# WOLF CREEK NUCLEAR OPERATING CORPORATION

March 14, 2007  
ET 07-0004

Subject: Docket No. 50-482: Revision to Technical Specification (TS) 3.3.2, "Engineered Safety Feature Actuation System (ESFAS) Instrumentation," TS 3.7.2, "Main Steam Isolation Valves (MSIVs)," and TS 3.7.3, "Main Feedwater Isolation Valves (MFIVs)"

Figure B 3.7.2-1  
MSIV Isolation Time vs. Steam Generator Pressure

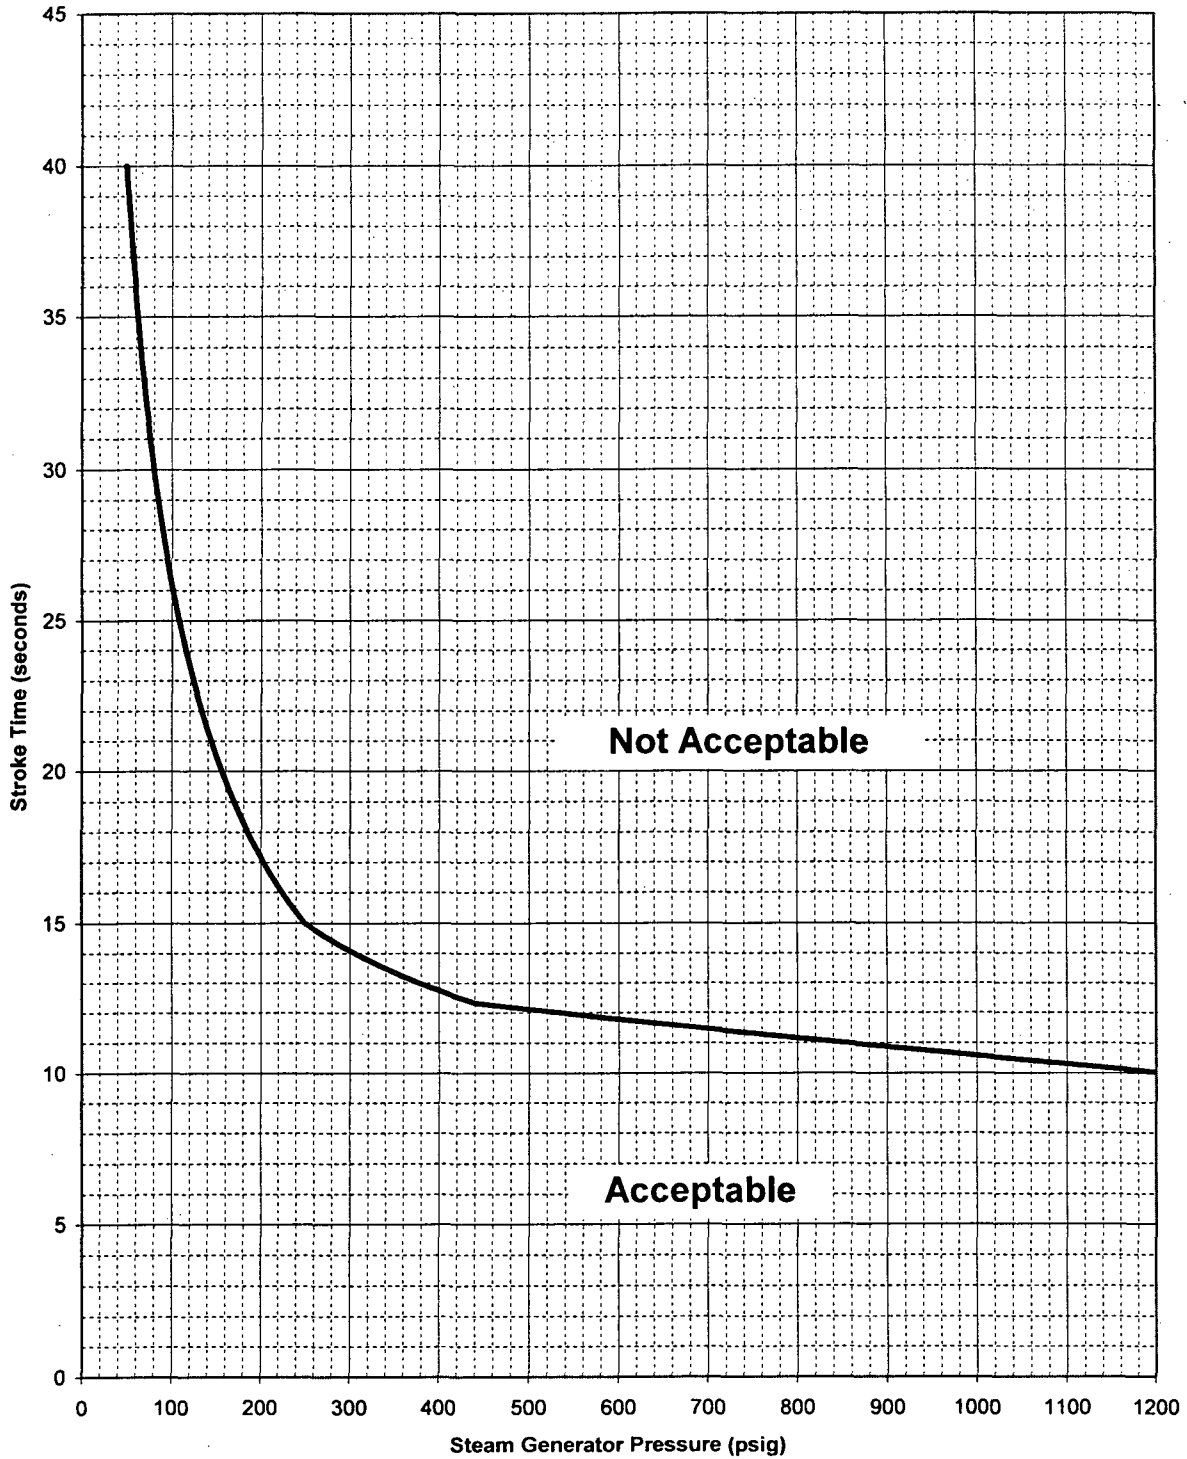
This SR verifies that the closure time of each MSIV is within the limits of Figure B 3.7.2-1 from each actuator train when tested pursuant to the Inservice Testing Program. The MSIV isolation time is explicitly assumed in the accident analyses that credit the Steam Line Isolation. Figure B 3.7.2-1 is a curve of the MSIV isolation time limit as a function of steam generator pressure. The acceptance curve for the MSIV stroke time conservatively accounts for potential pressure differential between the steam generator pressure indication and the pressure at the MSIV. This Surveillance is normally performed upon returning the unit to operation following a refueling outage.

INSERT FIGURE B 3.7.2-1 behind this page

Figure B 3.7.3-1  
MFIV Isolation Time Limit vs. Steam Generator Pressure

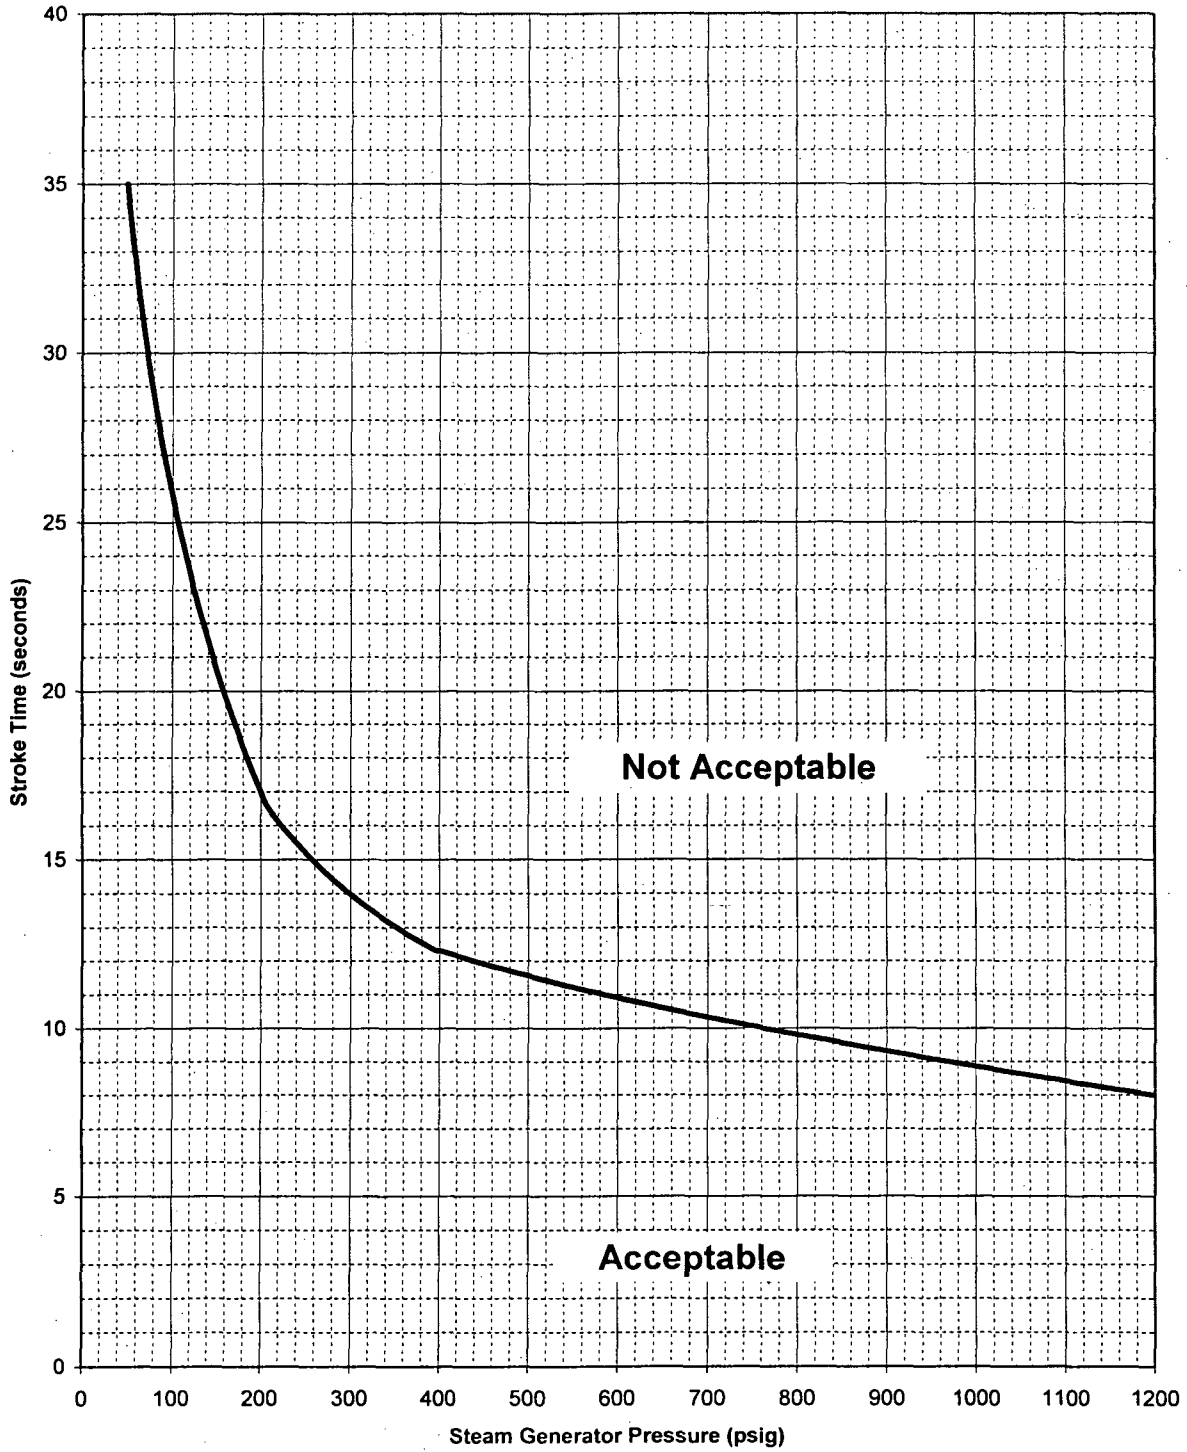
This SR verifies that the closure time of each MFIV, MFRV, and MFRV bypass valve is within limits (Figure B 3.7.3-1 for the MFIVs and  $\leq 15$  seconds for the MFRV and MFRV bypass valves) when tested pursuant to the Inservice Testing Program. The MFIV, MFRV, and MFRV bypass valve closure time is assumed in the accident and containment analyses. This Surveillance is normally performed upon returning the unit to operation following a refueling outage. This is consistent with Regulatory Guide 1.22 (Ref. 3). The Surveillance may be performed as required for post-maintenance testing of the MFRVs and MFRV bypass valves under appropriate conditions during applicable MODES. In particular, the MFRVs should normally not be tested at power since even a partial stroke exercise increases the risk of a valve closure with the unit generating power. However, when the plant is operating using the MFRV bypass valves (at low power levels during MODE 1), the surveillance for the MFRVs may be performed for post-maintenance testing during such conditions without increasing plant risk.

INSERT FIGURE B 3.7.3-1 behind this page
